FCC Class II Permissive Change Application Letter

ooma, Inc.

XFT-BFLY2, 03/27/2019

Change Contents: update the components on main board as below(The part to be modified is the peripheral circuit part of the RF module.):

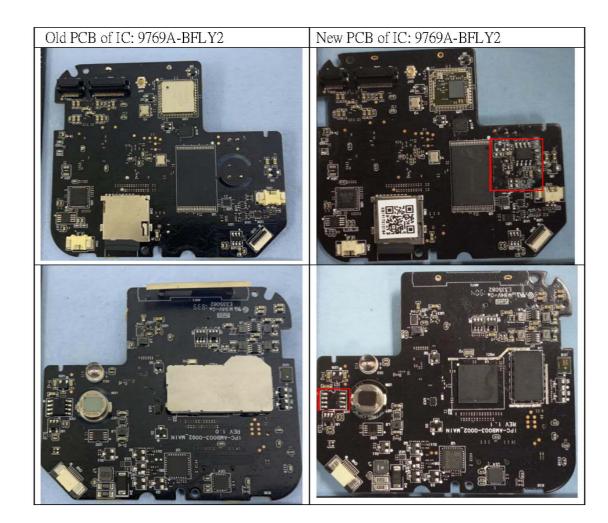
Old PCB of IC: 9769A-BFLY2	New PCB of IC: 9769A-BFLY2
with U15	Delete U15
with R242 (0R ±5% 1/20W 0201)	delete R242
with R176(100K ±1% 1/20W 0201)	delete R176
with R178(51K +-1% 1/20W 0201)	delete R178
without U1	add U1(AS085, SOP8 V7.01)
without C5	add C5(100pF 50V +/-10% 0402 X7R)
without C1,C3,C4	add C1,C3,C4(0.1uF 16V +80-20% 0402
	Y5V)
without C2,C10	add C2,C10(4.7uF ±10% 16V 0603 X5R)
without R5	add R5 (100K +-5% 1/16W 0402)
without R6	add R6 (10K +-5% 1/16W 0402)
without R1	add R1(47K ±5% 1/16W 0402
without R4	add R4(0R +-5% 1/16W 0402)
